**Addendum No. 1
September 20, 2024**

Project: LATC Surgical Technology Renovation
Lake Area Technical College
Watertown, South Dakota

Architect: CO-OP Architecture

SHEET TITLE:
POWER & DATA PLAN

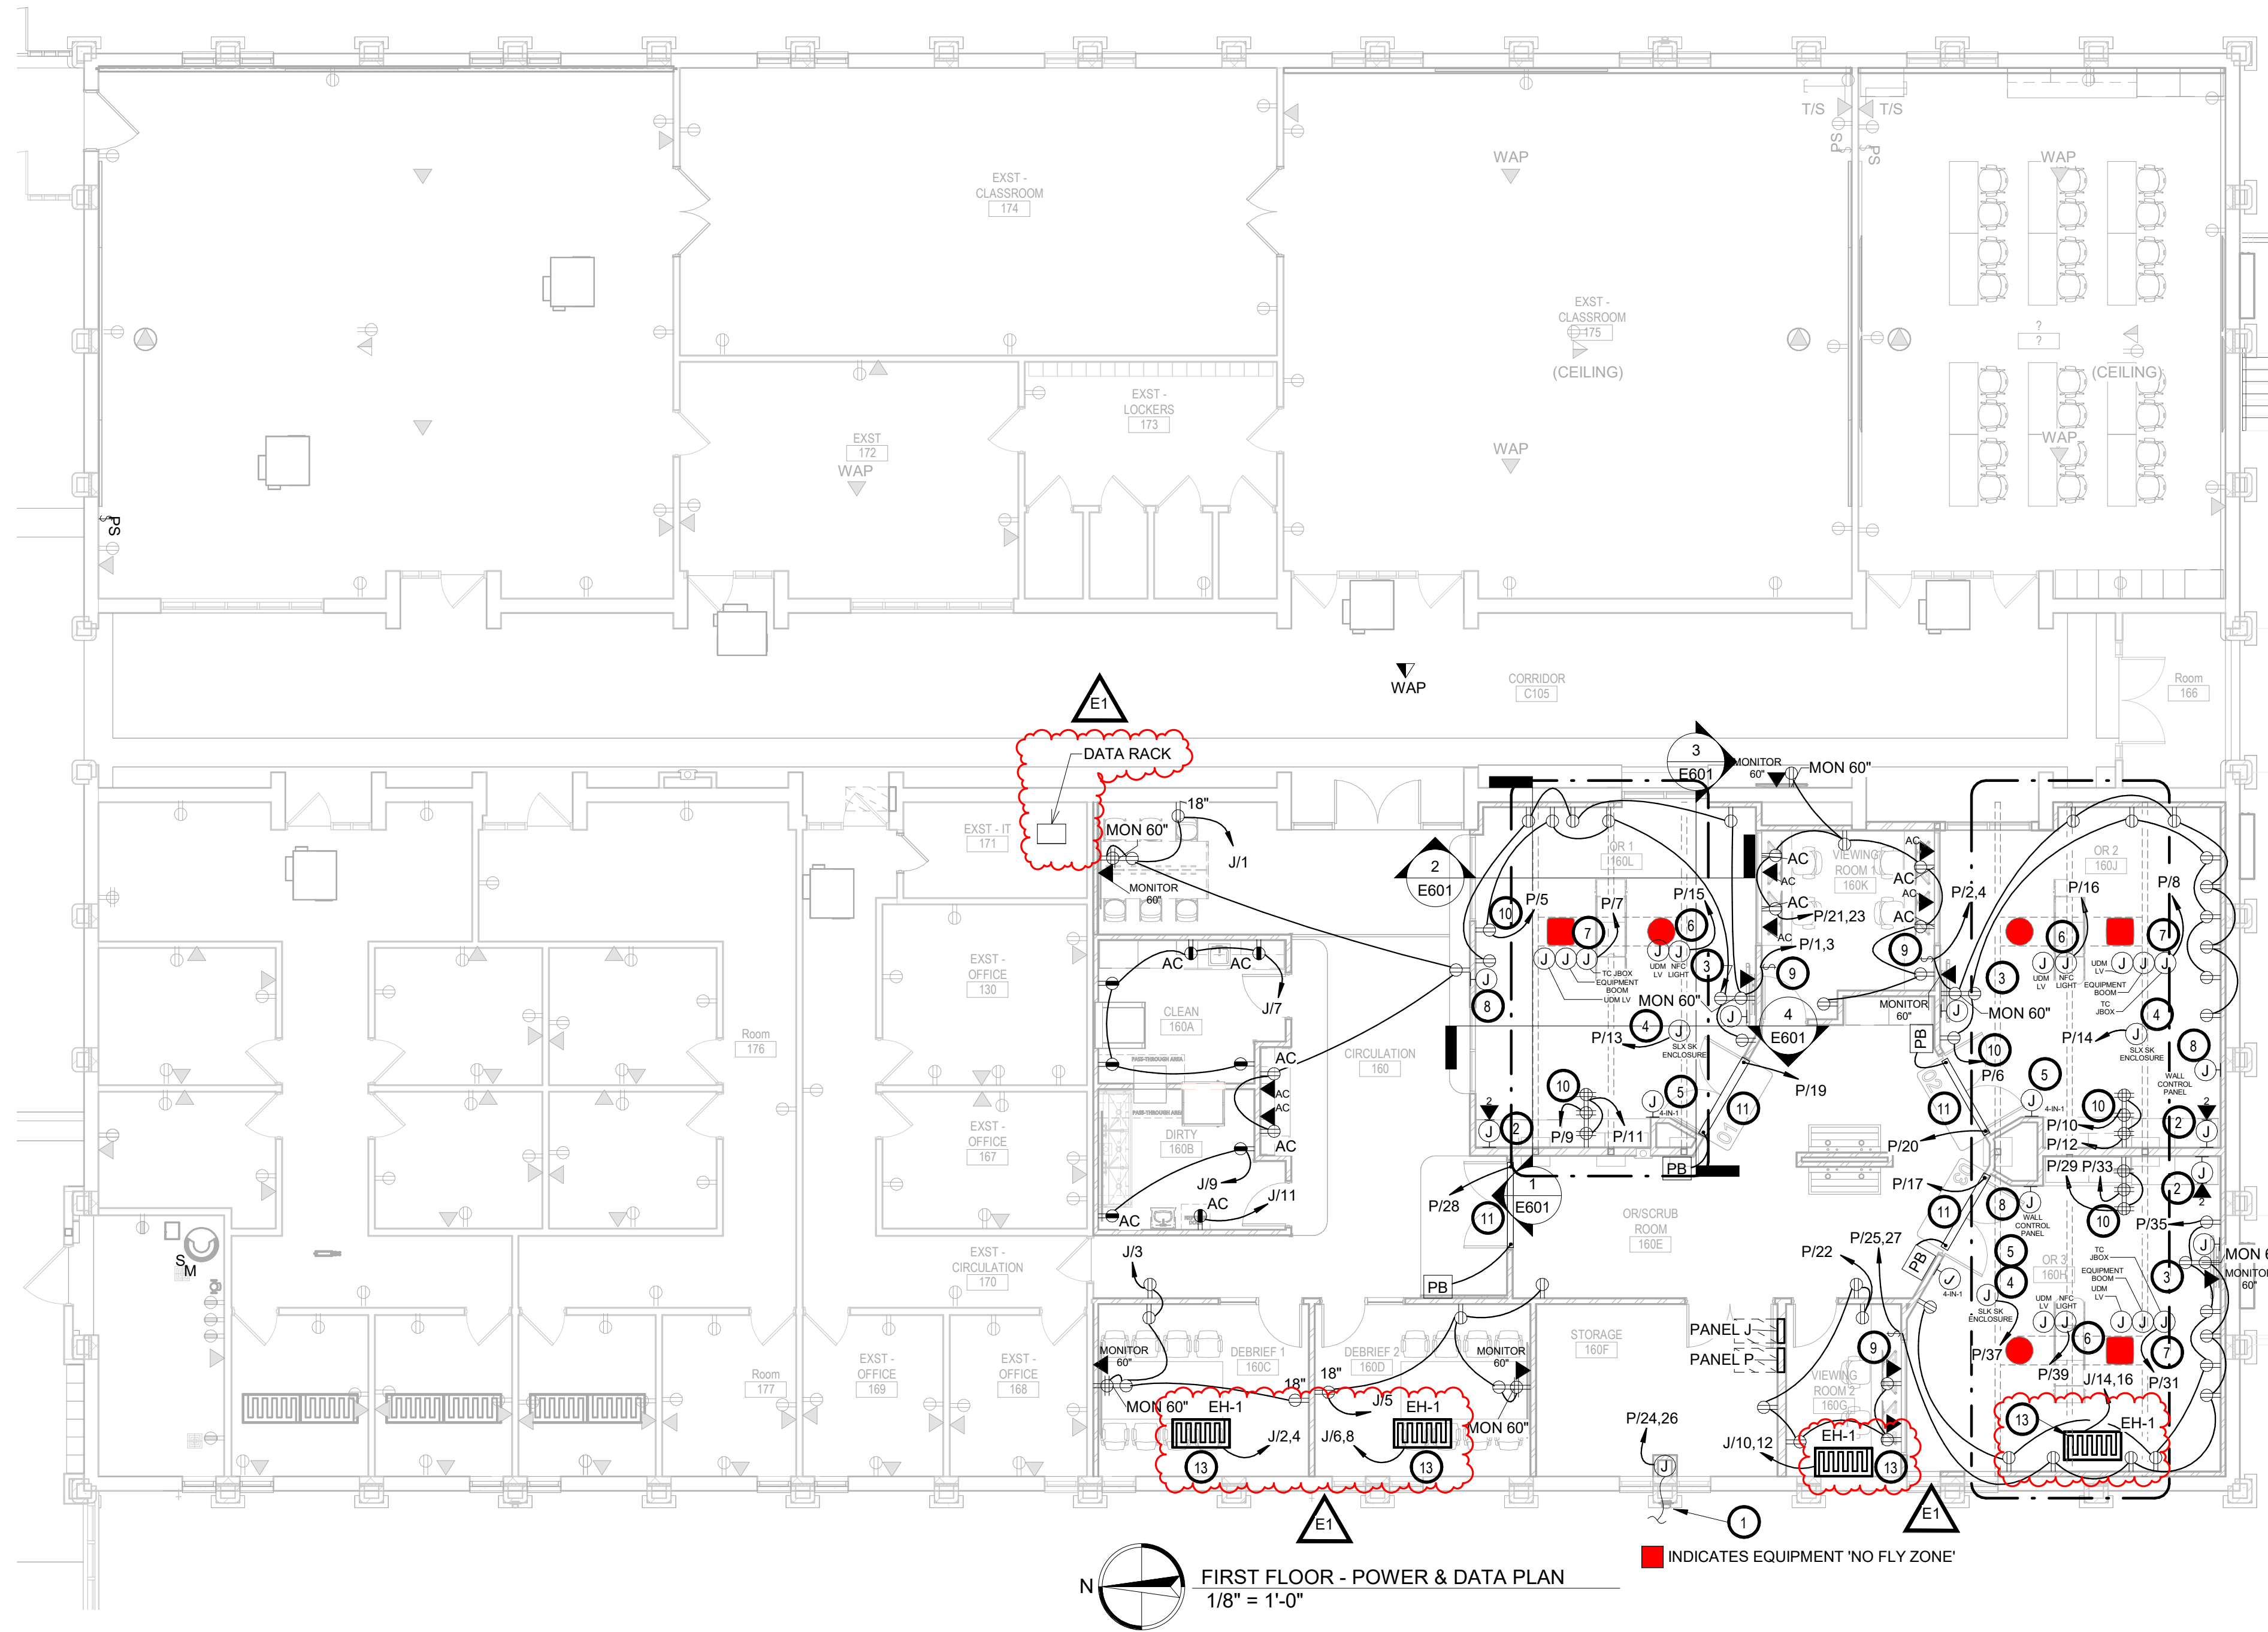
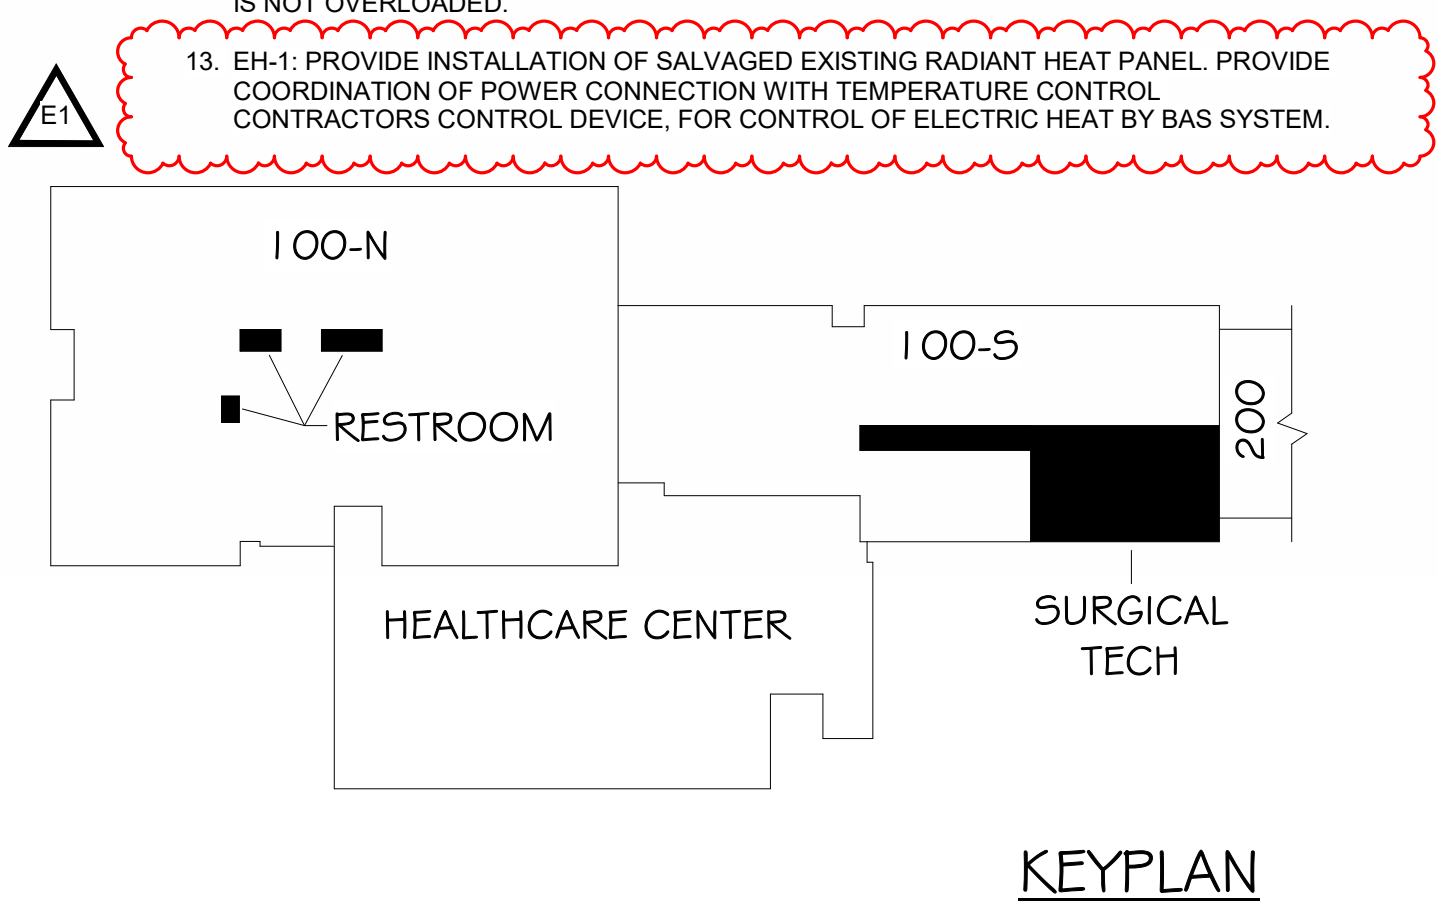
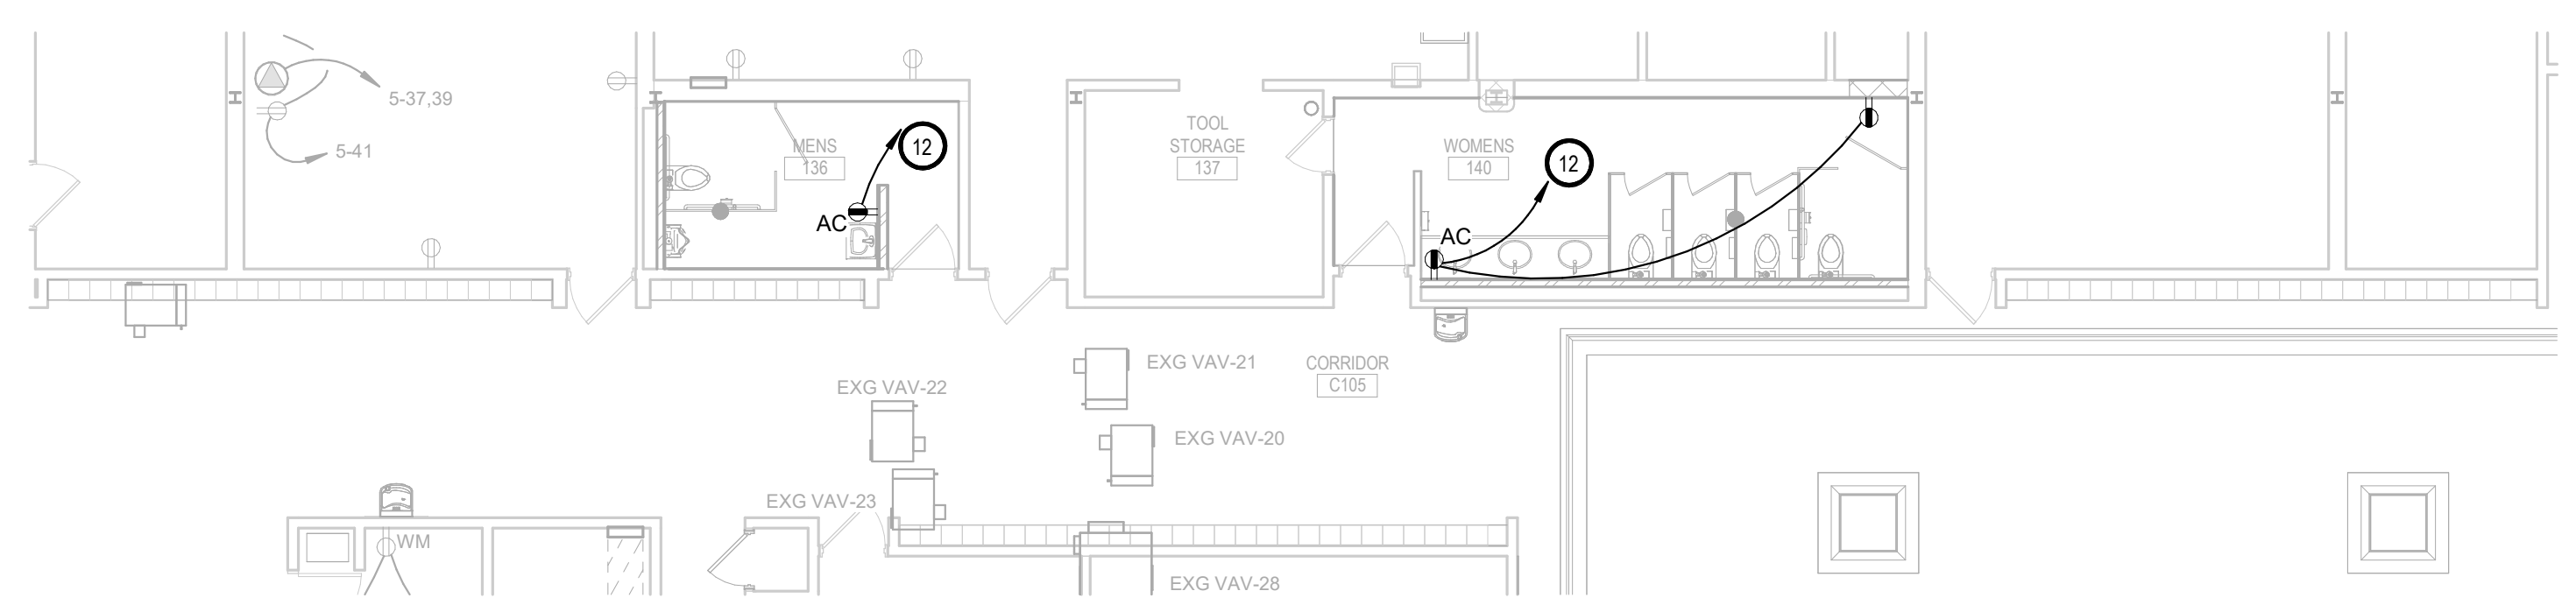
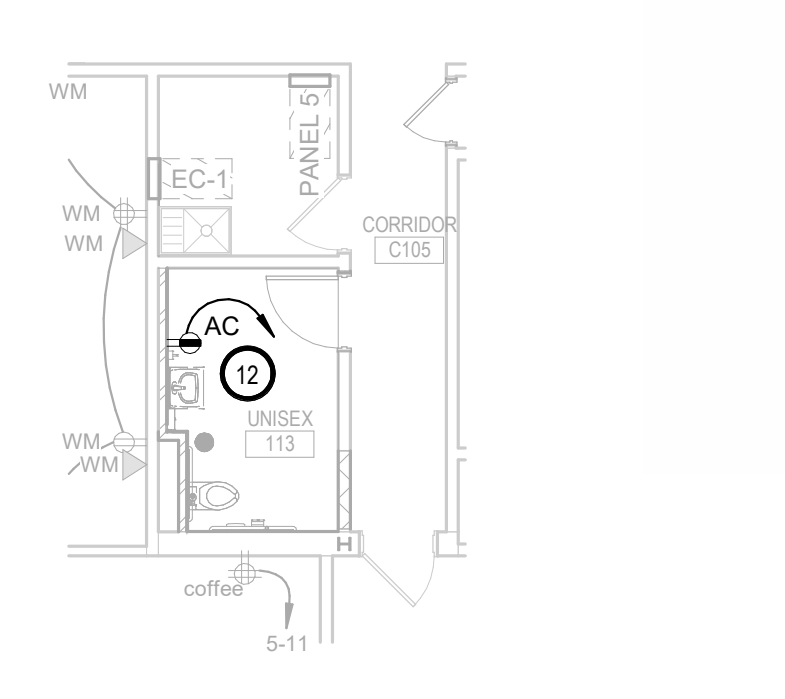
- Sheet E300 – Power & Data Plan
 - Added Keynotes for coordination with TC for BAS connection of EH-1. See attached revised sheet.
 - Added approximate location of Data Rack. Coordinate final location in field with owner.
 - See preliminary Stryker drawings (added by addendum) for additional information on OR equipment connections and rough-ins.
- Prior Approvals:
 1. Lighting Controls:
 - Cooper CAT – Mlazgar Associates

- CONNECT TO NEAREST 120 VOLT, 20 AMP BRANCH CIRCUIT. EC SHALL VERIFY CIRCUIT IS NOT OVERLOADED.
- EH-1: PROVIDE INSTALLATION OF SALVAGED EXISTING RADIANT HEAT PANEL. PROVIDE COORDINATION OF POWER CONNECTION WITH TEMPERATURE CONTROL CONTRACTORS CONTROL DEVICE, FOR CONTROL OF ELECTRIC HEAT BY BAS SYSTEM.
